APPLICATION FOR PERMIT TO DRILL OR REENTER

2. Name of Operator CONOCOPHILLIPS COMPANY		7. If Unit or CA Agreement, Name and No.
Contact: VICKI WESTBY E-Mail: VICKI.R.WESTBY@CONOCOPHILLIPS.COM		8. Lease Name and Well No. SAN JUAN 31-6 UNIT 216A
3a. Address 4001 PENBROOK ODESSA, TX 79762	3b. Phone No. (include area code) Ph: 915.368.1352	9. API Well No. 30-039-29409

## SUNDRY NOTICES AND REPORTS ON WELLS

ConocoPhillips Company requests to move the location of this well and drill directionally to the Fruitland Coal formation.

CONOCOPHILLIPS COMPANY SAN JUAN 31-6 UNIT #216A  
 98' FNL & 1086' FEL, SECTION 2, T30N, R06W, NMPM  
 RIO ARRIBA COUNTY, NEW MEXICO ELEVATION: 6383'

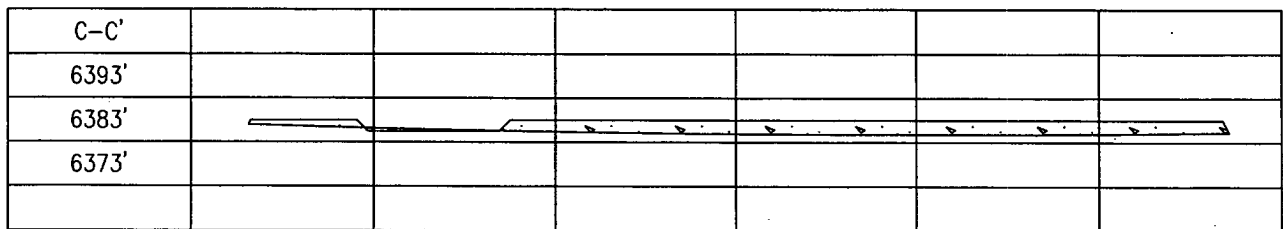
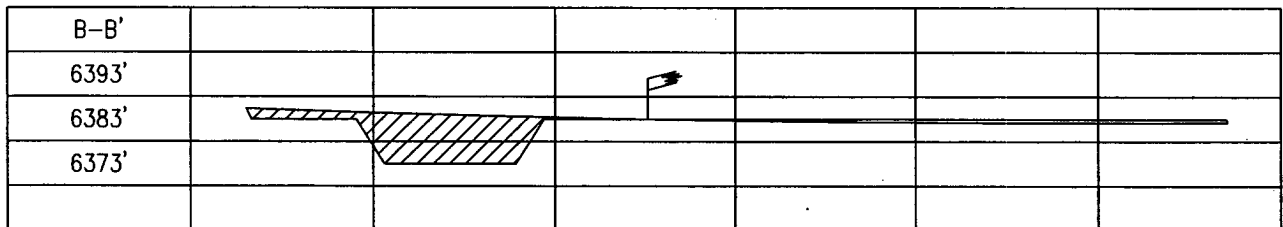
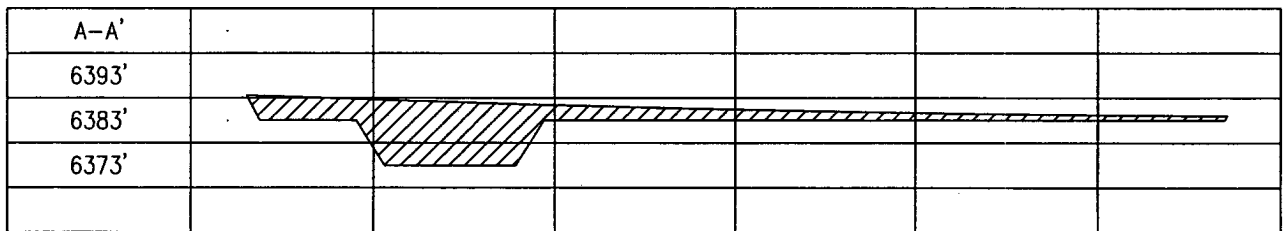
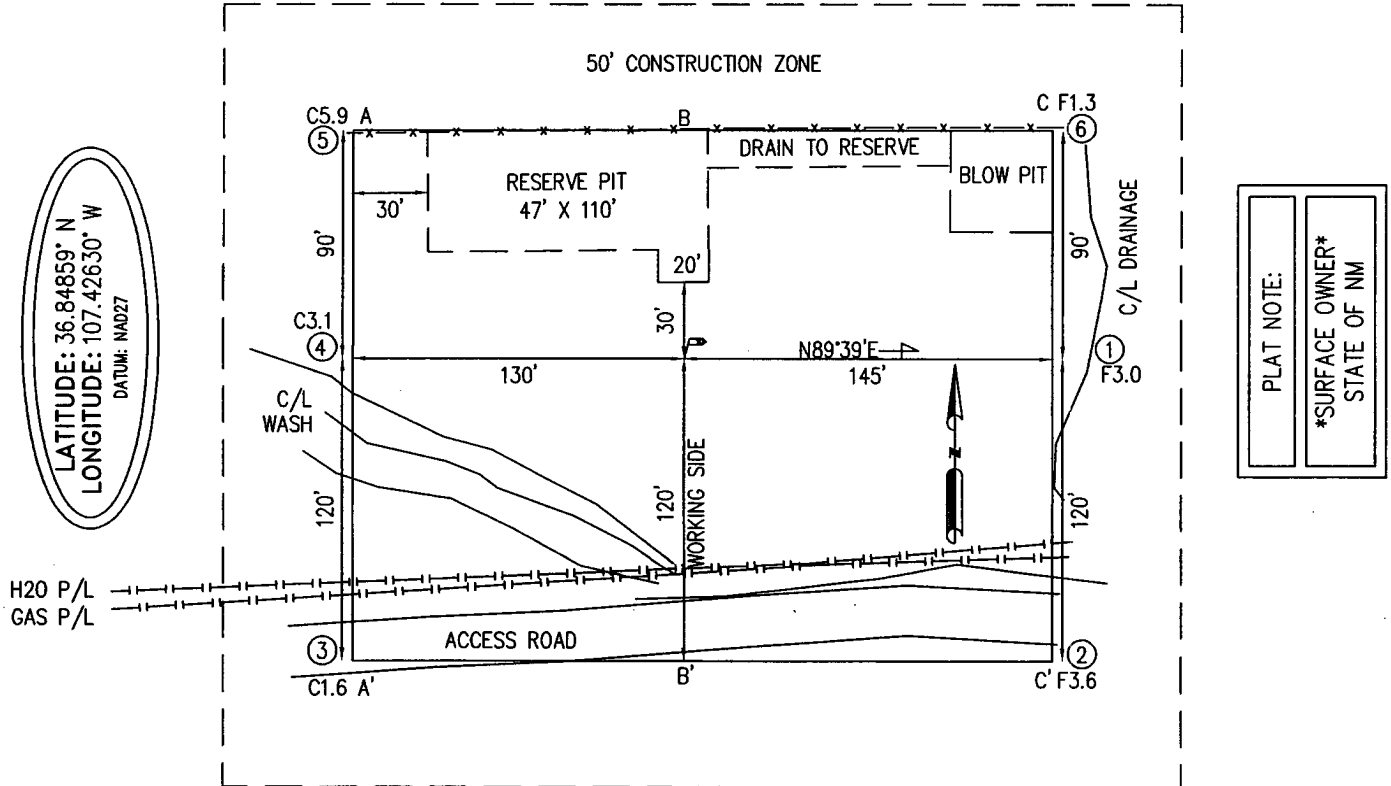
The pit will be constructed and closed in accordance with Rule 50 and as per COPC June 2005 General Pit Plan on file with the NMOCDD. See the attached diagram that details the location of the pit in reference to the proposed wellhead. The drill pit will be lined. The drill pit will be closed after the well has been completed

Field: Rio Arriba County, NM  
Site: San Juan 31-6 No. 216A  
Well: Well #216A  
Wellpath: Original Hole  
Plan: Plan #1

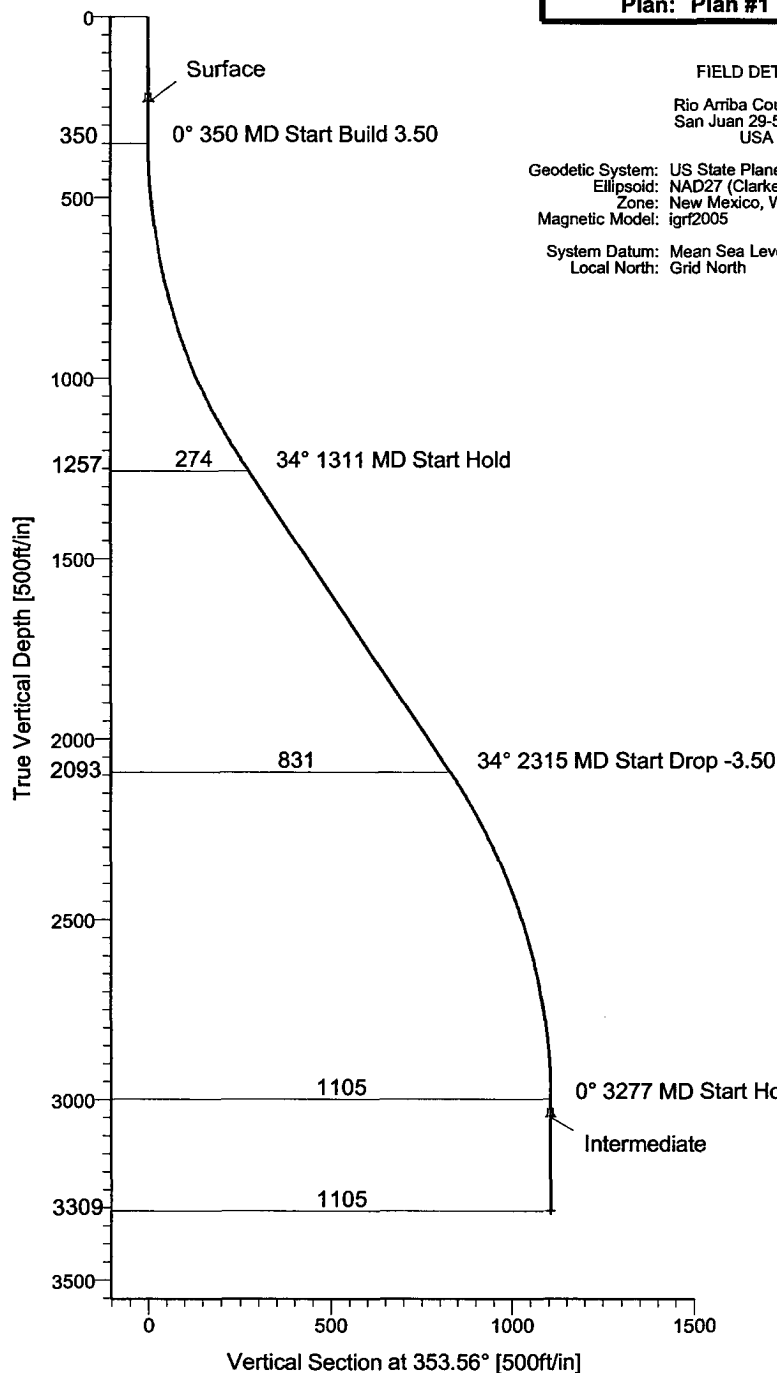
Location revised to a directional well drilled from section 2 to 1000' FSL & 1210" FEL of 31-6 section 35. The well has a BHL hardline = 1310' FSL and 1310" FEL (100' target radius).

Sec	MD	Inc	Azi	TVD	+N/-S	+E/-W	DLeg	TFace	VSec	Target
1	0.00	0.00	353.56	0.00	0.00	0.00	0.00	0.00	0.00	
2	350.00	0.00	353.56	350.00	0.00	0.00	0.00	0.00	0.00	
3	1311.46	33.65	353.56	1257.13	272.59	-30.78	3.50	353.56	274.32	
4	2315.44	33.65	353.56	2092.87	825.41	-93.22	0.00	0.00	830.66	
5	3276.90	0.00	353.56	3000.00	1098.00	-124.00	3.50	180.00	1104.98	
6	3585.90	0.00	353.56	3309.00	1098.00	-124.00	0.00	0.00	1104.98	PBHL
